ADMINISTRATIVE AMENDMENT (FPA) ADD2014-00213
ATTACHMENT "C"
ADMINISTRATIVE AMENDMENT
LEE COUNTY, FLORIDA

FINAL PLAN APPROVAL
UNIVERSITY VILLAGE PHASE I
AT MIROMAR LAKES

**STAFF REPORT
FROM
DEPARTMENT OF COMMUNITY DEVELOPMENT
DIVISION OF ENVIRONMENTAL SCIENCES**

Project: University Village

① LAKE CROSS SECTION WITH TURF REINFORCEMENT MAT

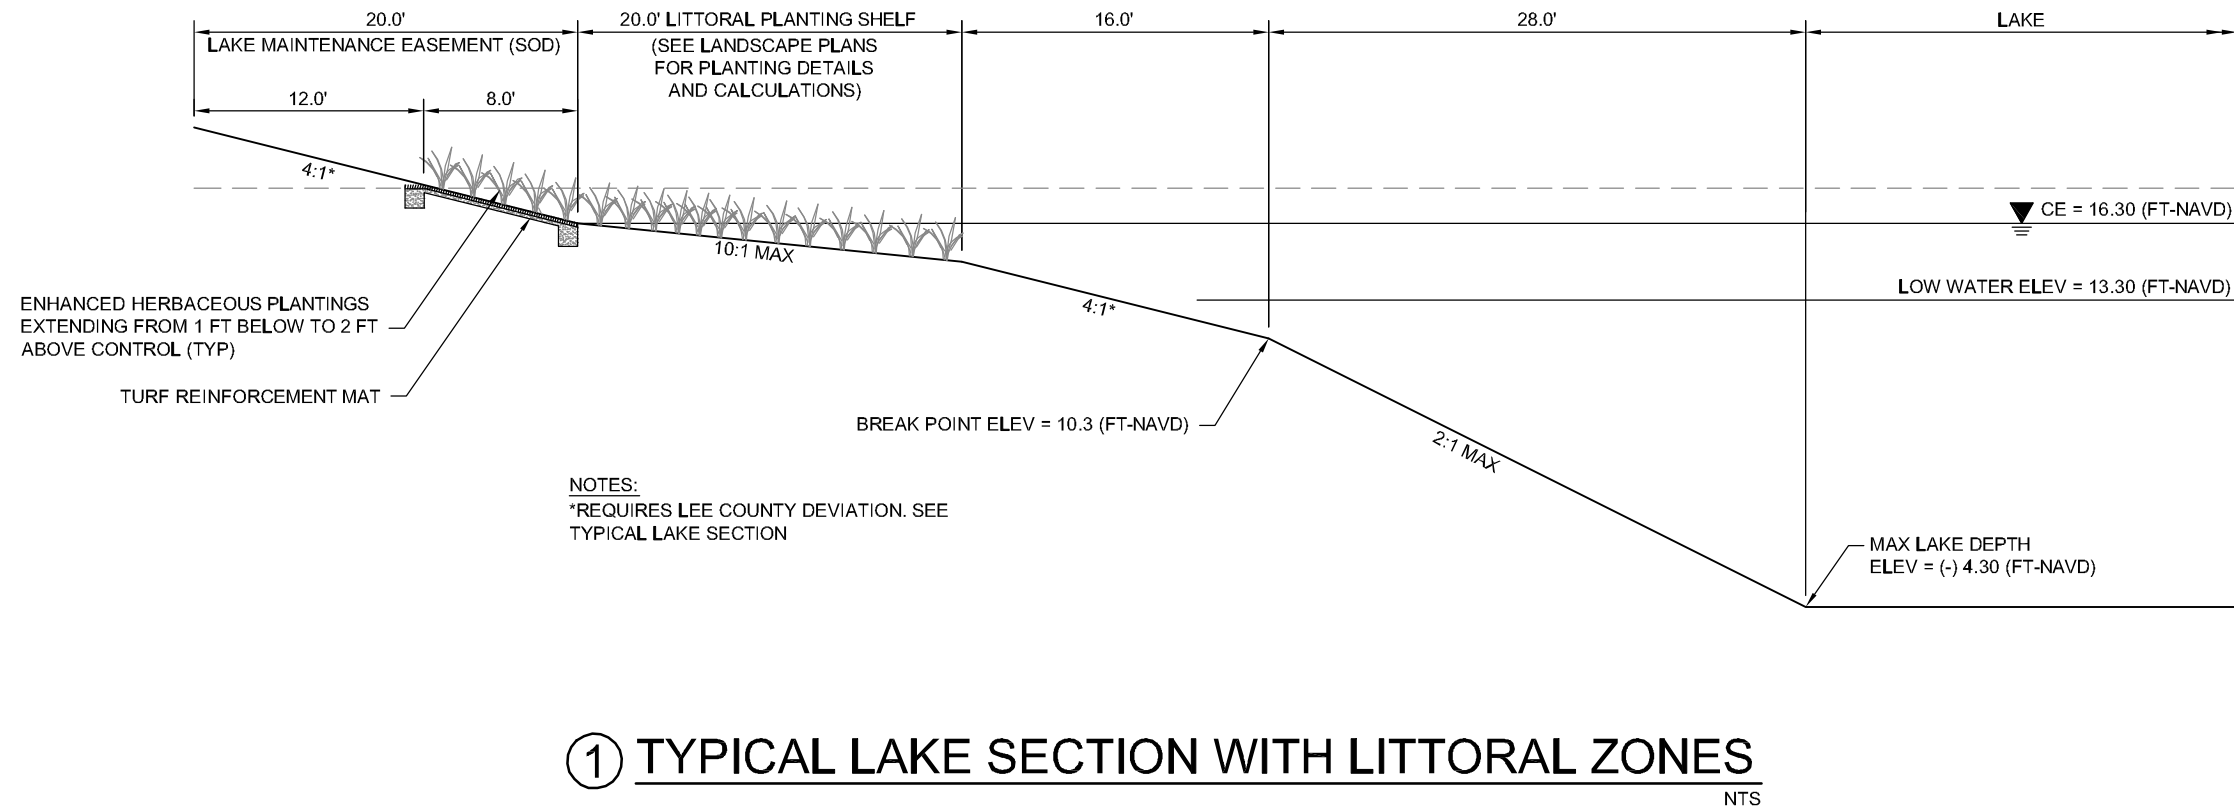
Deviation #1 requests to deviate from LDC Section 10-329(d)(4) requiring lake banks to be sloped at 6:1 ratio from the top of bank to a water depth of two feet below dry season water table: to allow for a minimum ratio of 4:1 where turf reinforcement mat is proposed.

The FPA depicts turf reinforcement mats proposed along the entire shoreline of the two lakes except where bulkhead is proposed for a total of 4,020± linear feet (4,440-420). The lake bank cross sections indicate that the enhanced littorals, used in combination with appropriate turf reinforcement mat as required by LDC Section 329(d)(4) and install a minimum 6,500 littorals at a minimum 2-feet below control to 2-feet above control for a total of 6,500 enhanced littorals. ES staff does not object to the deviation requests and defers to Development Services staff for final recommendation.

Regarding requested deviation no. 1 (from the required 6:1 bank sideslope to allow a 4:1 sideslope): Staff supports this deviation with the condition that turf reinforcement be provided to mitigate bank erosion and the bank sideslopes are maintained by the appropriate entity in perpetuity.

Condition #1 – Development order landscape plans must depict a total of 6,500 enhanced littorals provided in combination with the turf reinforcement mats. These enhanced littoral plantings are required in addition to the code minimum littoral plantings and the increased littorals to offset the bulkhead shoreline.

Condition #2 – Turf reinforcement be provided to mitigate bank erosion and the bank sideslopes are maintained by the appropriate entity in perpetuity.
7. **Deviation #2 is approved.**

If the deviation moves forward with an approval ES staff recommends the following condition to ensure that enhanced littorals as proposed by the applicant are provided:

Development order landscape plans must depict a total of 6,500 enhanced littorals provided in combination with the turf reinforcement mats. These enhanced littoral plantings are required in addition to the code minimum littoral plantings and the increased littorals to offset the bulkhead shoreline.
